Exchange of information on national and international requirements on noise levels

Reference to documents GRB-60-08, GRB-60-12, GRB-60-14-Rev.1 and GRB-61-03 from the Netherlands.

Ref.: GRB-60-8-Add 1 page 3: "The 2007 population is based on FEHRL/TÜV/NL data for **C2 and C3**"

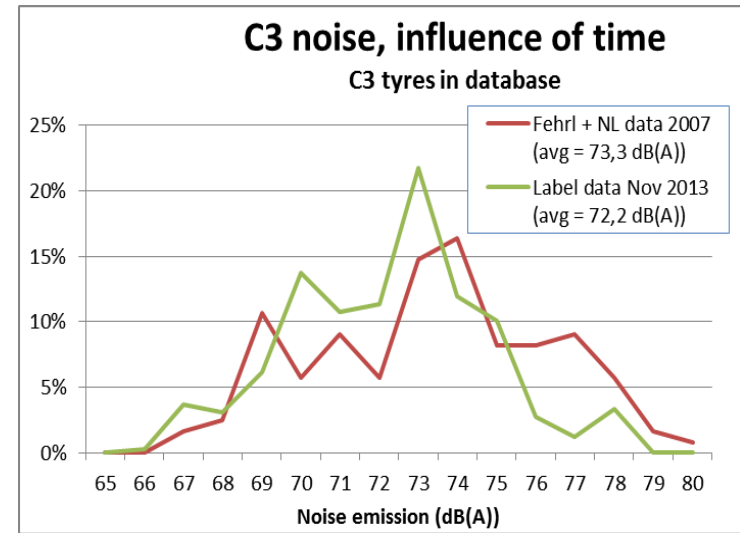
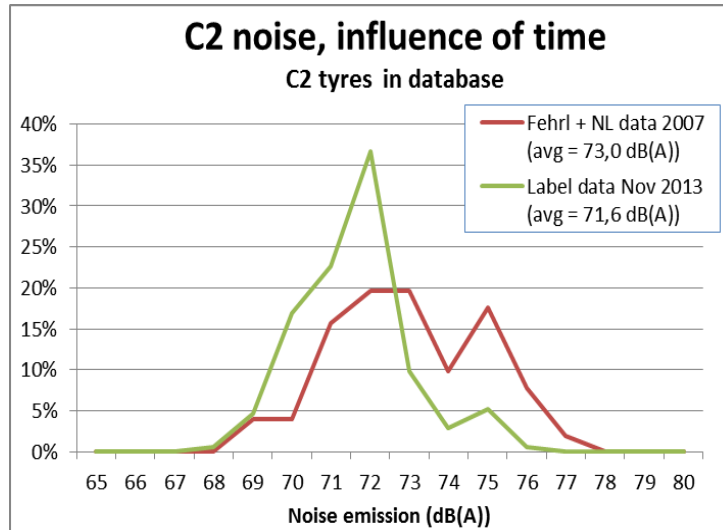
The data from FEHRL were not representative of the market nor tyres (sizes, load indexes, speed symbols, market segments, etc.) available in 2007.

Morover, few data points available for C2 (19) and C3 (98) tyres.

(There are several thousands of tyre types on the market.)

Ref. GRB-60-08 page 3:

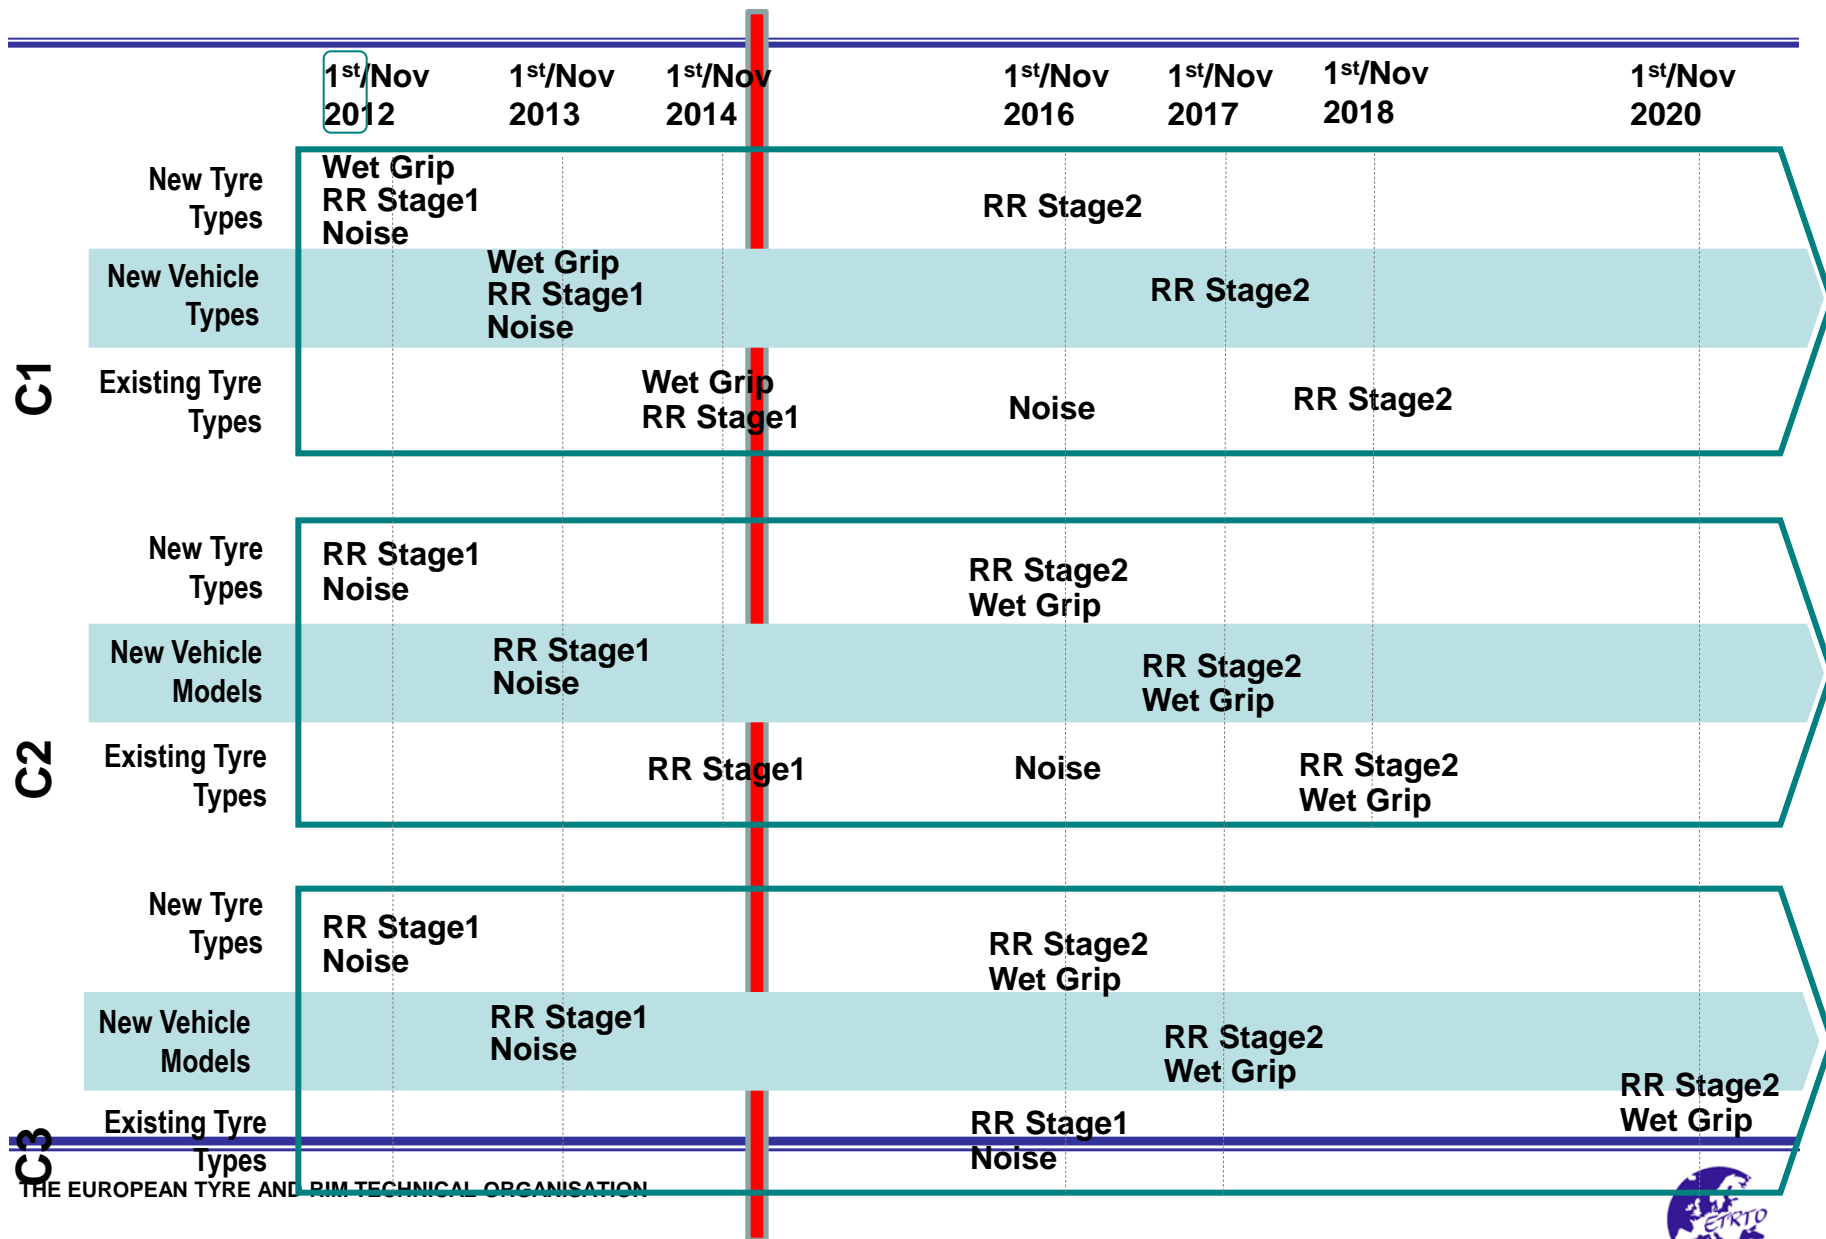
The VACO database use a specific code which is very much related to the EAN coding but there is no indication of the sales volume.

This database is linked to tyres sold in the Netherlands only and may not be representative of tyre sold in countries adopting the 1958 Agreement.

We question the conclusion based on the adopted criteria for sample sizes selection. Tyres that have been excluded are anyhow in the market!
